SNUPPS

SLNRC 82-07 FILE: 0541
SUBJ: NRC Request for Additional
Information - Reactor Systems

Docket Nos: STN 50-482 and STN 50-483

SNUPPS
Figure 440.1-1
Nuclear Power Transient,
Locked Rotor With and Without
Offsite Power

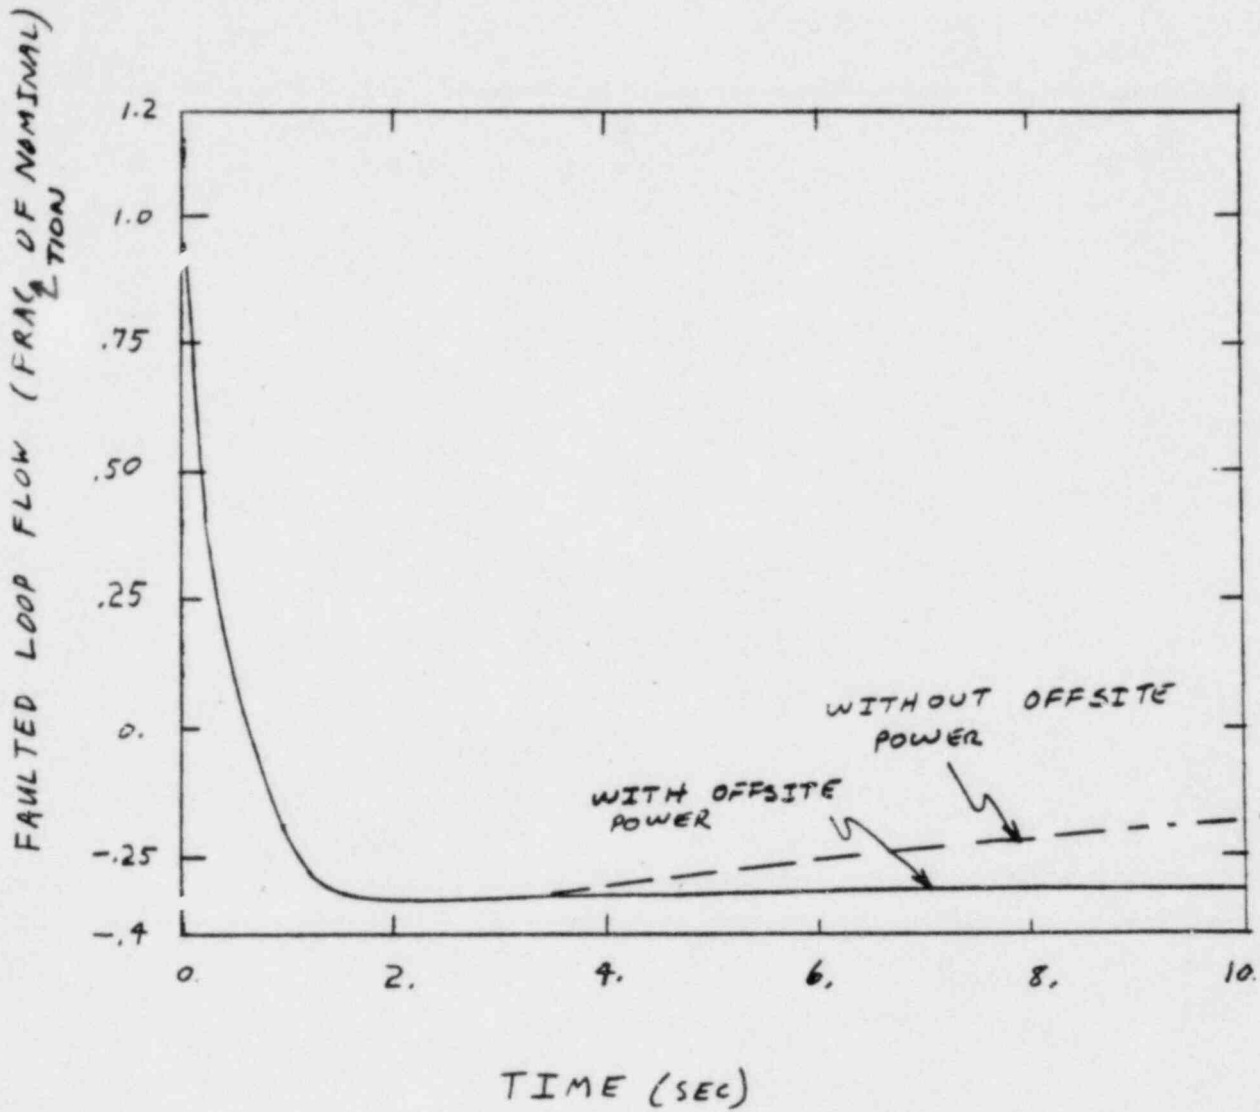
440.1 The analyses of a locked reactor coolant pump rotor and a sheared
(440.3WC) reactor coolant pump shaft in the FSAR assumes the availability of
(440.1C) offsite power throughout the event. In accordance with Standard
Review Plan 15.3.3 and GDC 17, we require that this event be
analyzed assuming turbine trip and coincident loss of offsite power
to the undamaged pumps.

The event should also be analyzed assuming the worst single failure
of a safety-system active component. Maximum technical specification
primary system activity and steam generator tube leakage should be
assumed. The analyses should demonstrate that offsite doses are less
than 10 CFR 100 guidelines values.

Figures 440.1-1 through 440.1-5 show a comparison between the locked rotor transient without offsite power and the locked rotor transient with offsite power from section 15.3.3. As can be seen from the figures, losing offsite power results in the same peak clad temperature and the same peak RCS pressure.

The locked rotor without offsite power transient is no more limiting than the case presented in Section 15.3.3.
